**Submission
No 374**

INQUIRY INTO IMPACT OF THE WESTCONNEX PROJECT

Organisation: Inner West LEAN

Submission to the New South Wales Legislative Council’s Public Accountability Committee Inquiry into the impact of the WestConnex Project

Figure 6-3 Daily network traffic statistics (based on preliminary traffic modelling)

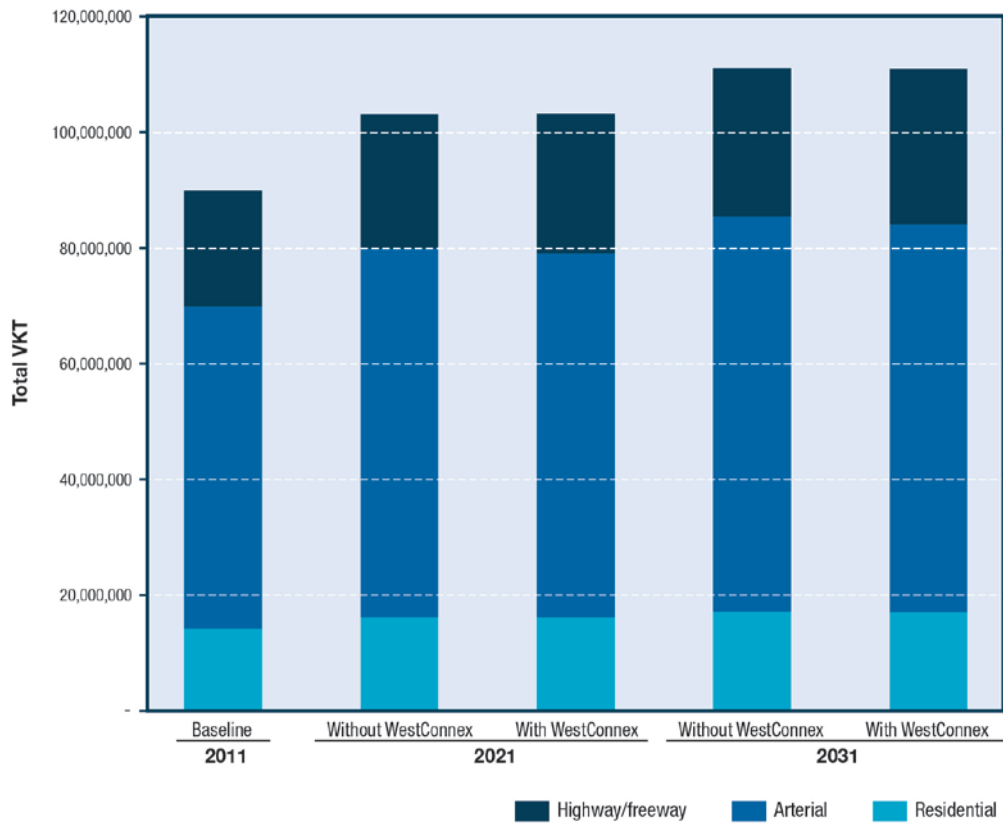
A major impact of Westconnex on air quality is the consequence of the increased traffic flows projected to use it in 2031 as compared to 2012. This has not been addressed in the published documents and this is a major shortcoming. Comparing the impact of WestConnex to the impact without Westconnex does not reveal the impact on air quality of the increased traffic flows that are provided for under WestConnex

The WestConnex documents should set out the impact on air quality of the increased VKTs projected. That is the absolute increase in air pollution between 2012 and 2031. It is a distraction to find that the levels of emissions with and without WestConnex were essentially the same. This is because if there was no WestConnex there are alternatives to the without WestConnex scenario.

Figure 6-4 Daily network traffic statistics (based on revised traffic modelling)

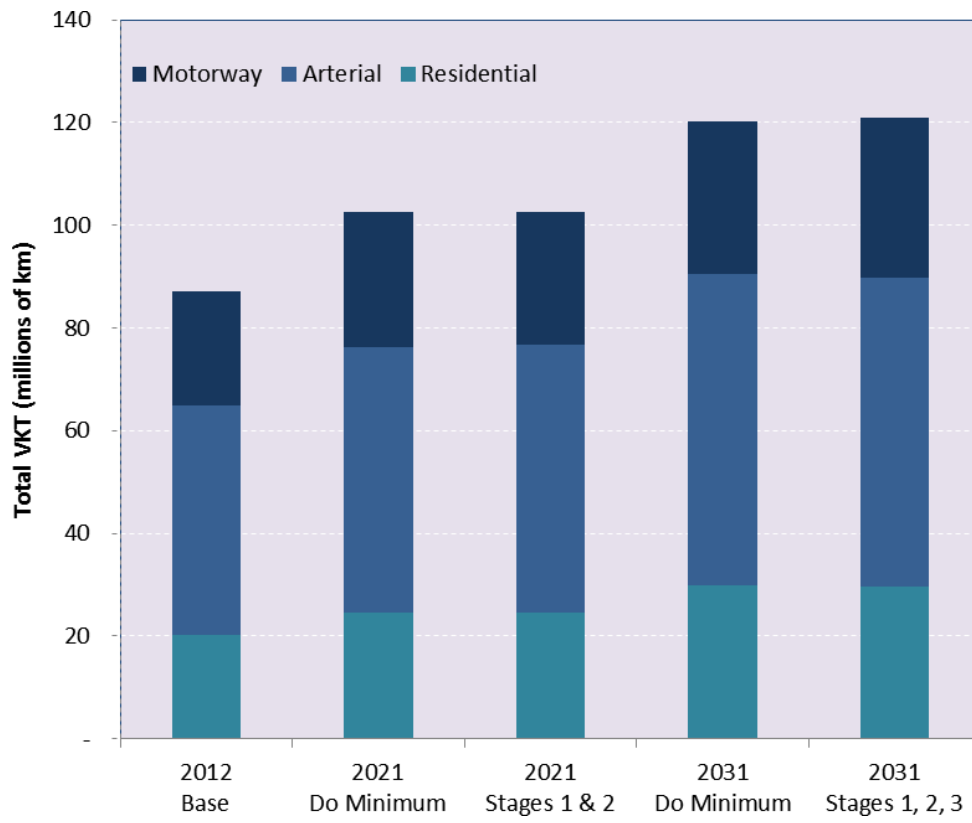
The concern here is that there will be an absolute increase in air pollution in the Sydney basin as a consequence of the projected increase in vehicle kilometres travelled (VKT). This increase is likely to be significant, as Figure 6-4 shows the increase in VKT will be from 90 million in 2012 to 120 million per year in 2031. The consequent absolute increase in air pollution has not been published anywhere in the WestConnex documents.

The Committee is requested to seek information in respect of the absolute increase in air pollution as a consequence of the increase in Vehicle Kilometres Travelled between 2012 and 2031.

The Committee is requested to seek information in respect of the impact on public health in the Sydney region as a consequence of the absolute increase in air pollution associated with the increase in VKT between 2012 and 2031
